ALISO CANYON TURBINE REPLACEMENT PROJECT

FINAL ENVIRONMENTAL IMPACT REPORT

JUNE 2013

State of California
Public Utilities
Commission

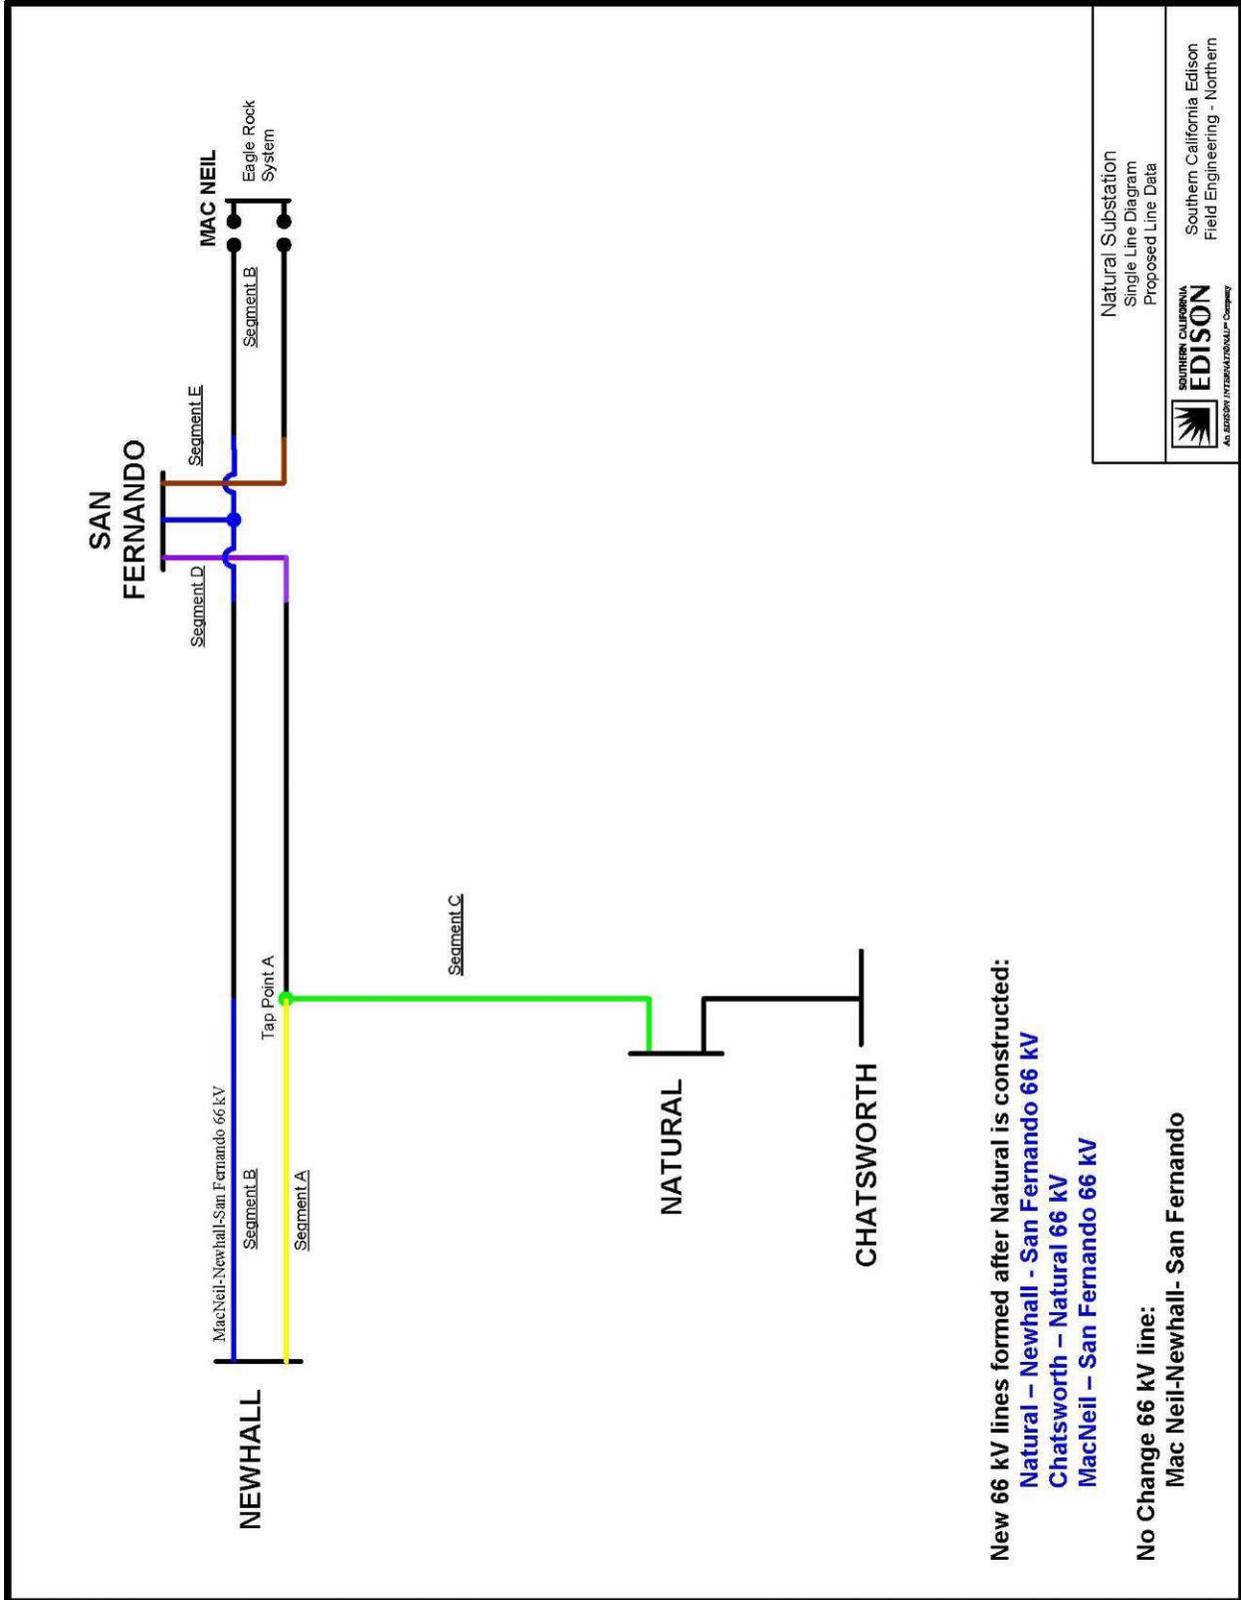
New 66 kV lines formed after Natural is constructed:
 Natural – Newhall - San Fernando 66 kV
 Chatsworth – Natural 66 kV
 MacNeil – San Fernando 66 kV

No Change 66 kV line:
 Mac Neil-Newhall- San Fernando

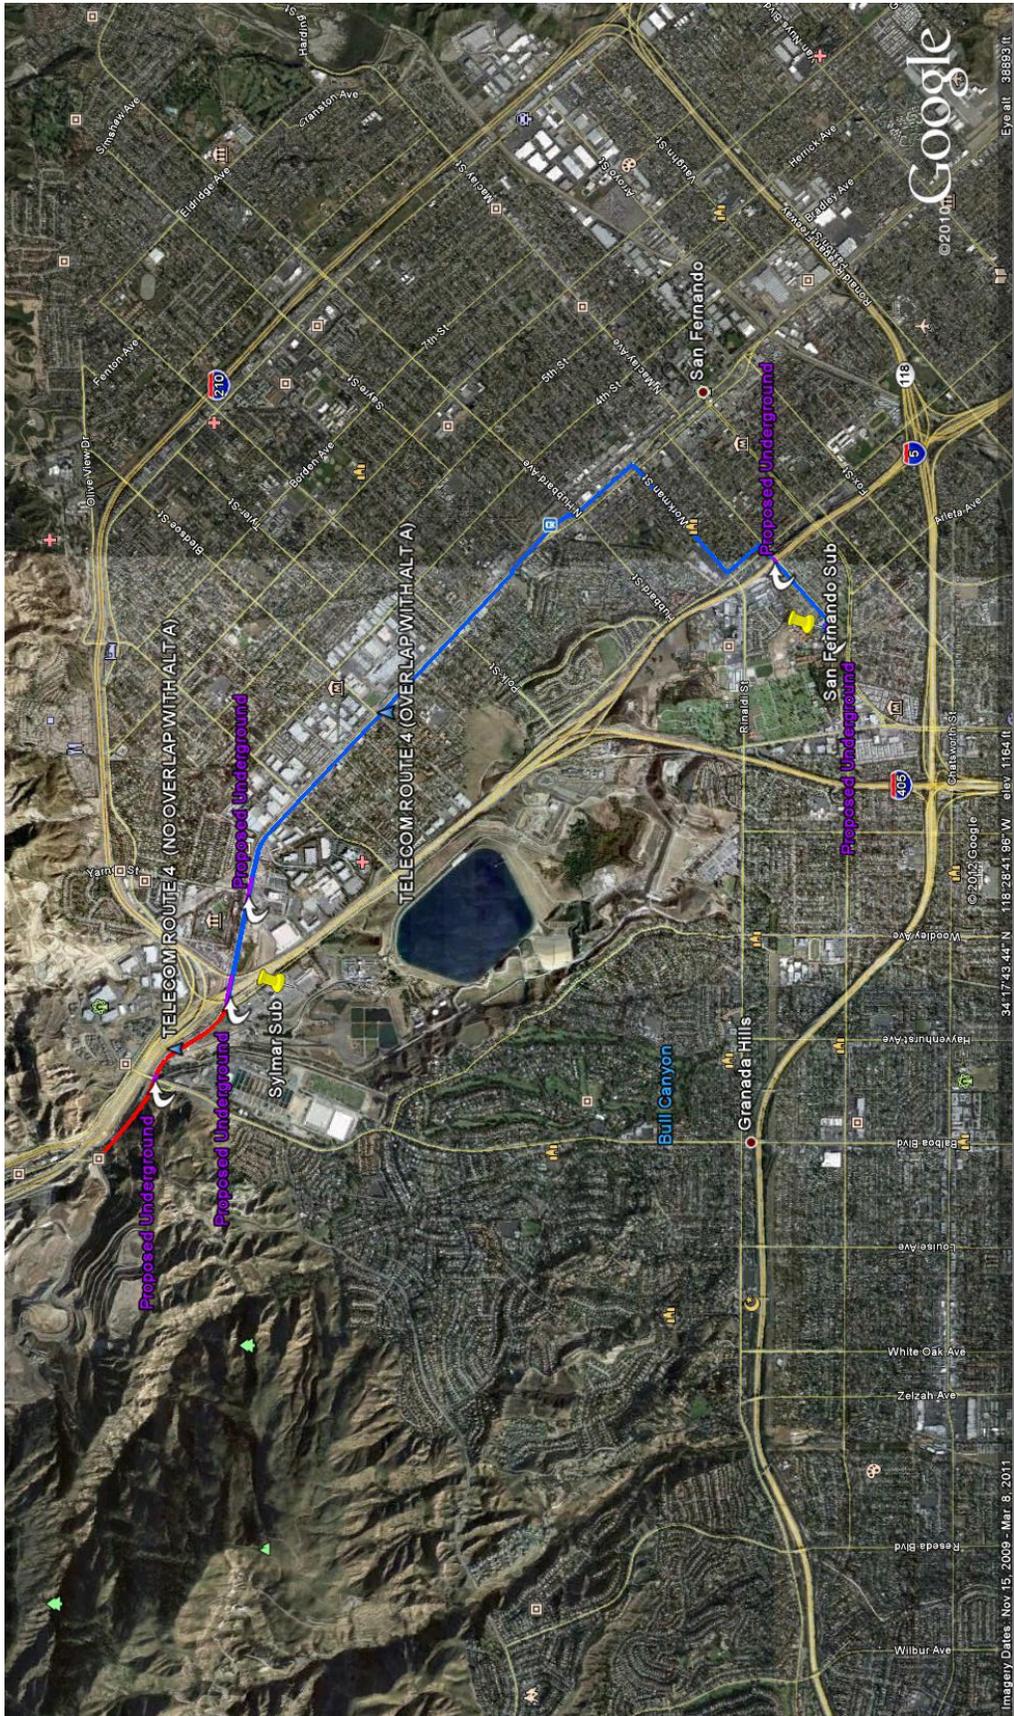
This route would extend approximately 5.5 miles from the San Fernando Substation to the entrance of the Sunshine Canyon Landfill as follows:

O1-83

Figure 2-3
New Pipelines to Connect the Proposed Central Compressor Station to Existing Facilities

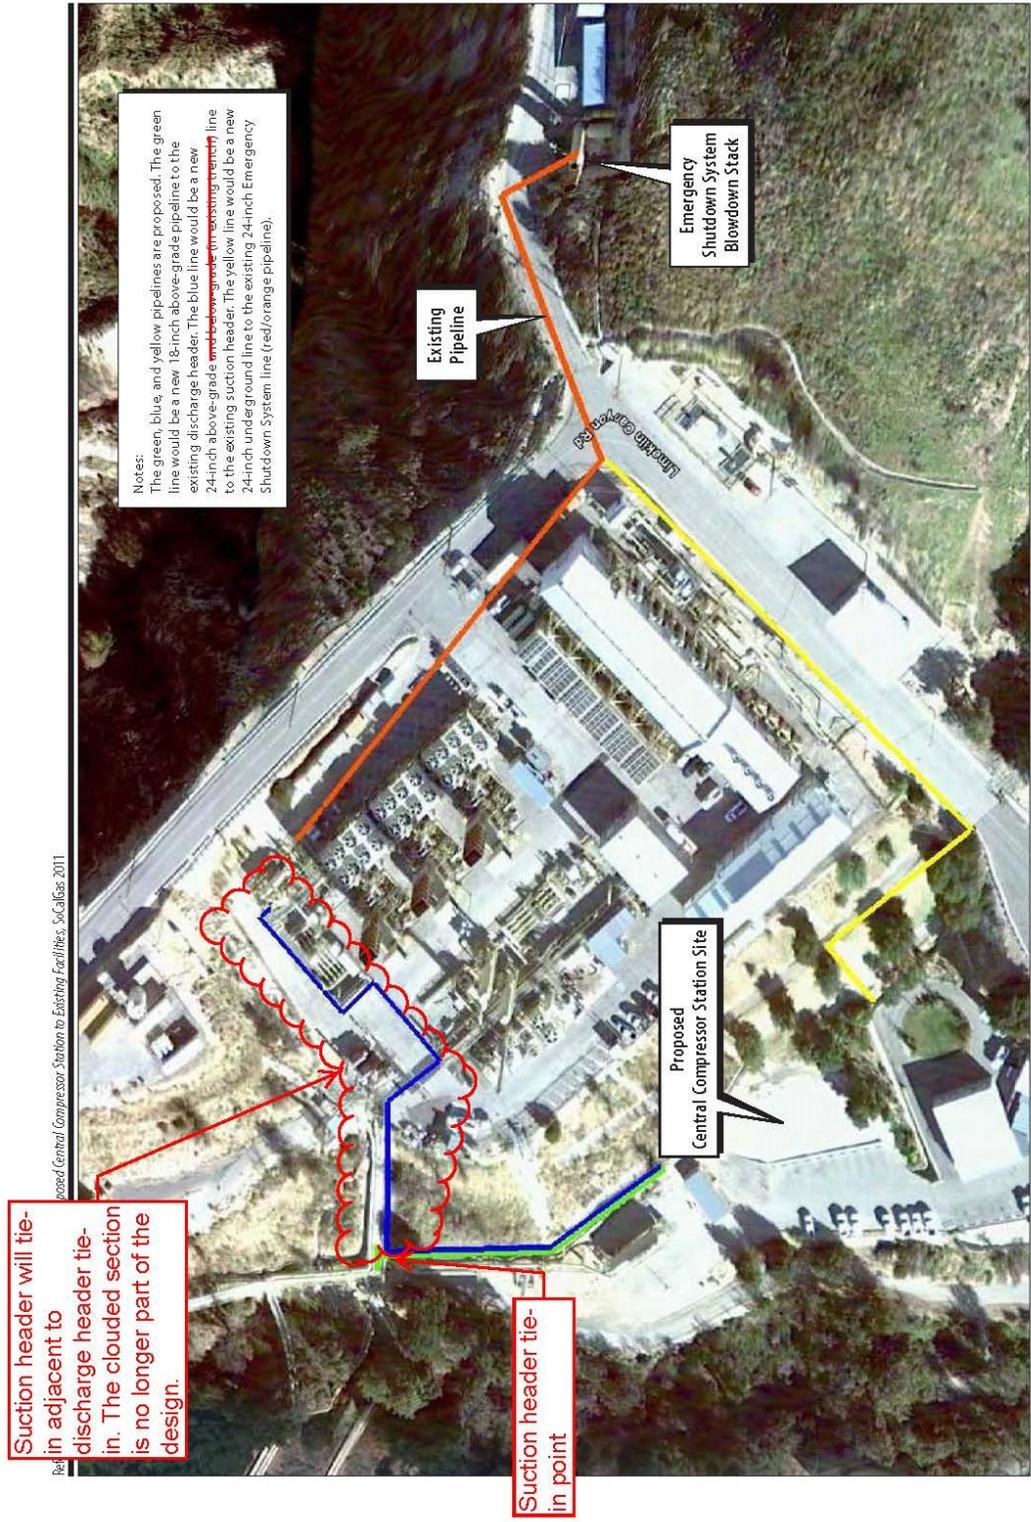
Master Comment Table						
Comment No.	Section	Page	Lines	Original Text	Suggested Revision	Comment
						Please see revised Figure 2-4 as provided in Exhibit O2-41 A-3 of the accompanying cover letter. Cont.
28	Project Description	2-10	12	"Water, sediment, liquid hydrocarbons, and other chemicals..."	Revise as follows: "Water, sediment, oil and liquid hydrocarbon condensates, and other chemicals..."	Under the heading 2.1.1 Storage Field Operations and Technical Details , the phrase "other chemicals" does not accurately characterize withdrawn materials and should be deleted. Hydrocarbon condensate more accurately describes withdrawn materials. O2-42
29	Project Description	2-10	28	"Each compressor generates 15,000 horsepower"	Revise as follows: "Each compressor is ISO rated at generates 15,000 horsepower..."	Under the heading 2.1.1 Natural Gas Injection and Withdrawal , the current description of compressor horsepower is not accurately described and should reference the ISO rating. O2-43

Comment O2-195
refers to all Exhibit A-3

- O2-40:** Refer to revisions made to EIR Chapter 2.0, “Project Description,” including Figure 2-3, as presented in Appendix A of this Final EIR.
- O2-41:** Refer to revisions made to EIR Chapter 2.0, “Project Description,” including Figure 2-4, as presented in Appendix A of this Final EIR.

- O2-194:** Exhibit A-2 is included in this Final EIR as Appendix C-1. Refer also to revisions made to EIR Section 4.4, “Biological Resources,” as presented in Appendix A of this Final EIR.
- O2-195:** The revisions of Figures 2-3 and 2-4 as presented in Exhibit A-3 have been incorporated into this Final EIR. Refer to revisions made to EIR Chapter 2.0, “Project Description,” as presented in Appendix A of this Final EIR.
- O2-196:** No revision is required. Refer to response to comment O2-62.
- O2-197:** Exhibit A-5 has been incorporated into this Final EIR as Appendix C-3. Refer also to revisions made to EIR Section 4.11, “Noise,” as presented in Appendix A of this Final EIR.
- O2-198:** Refer to Master Response to Comments About CEQA Significance Determinations (No Impact Versus Less Than Significant Impact).
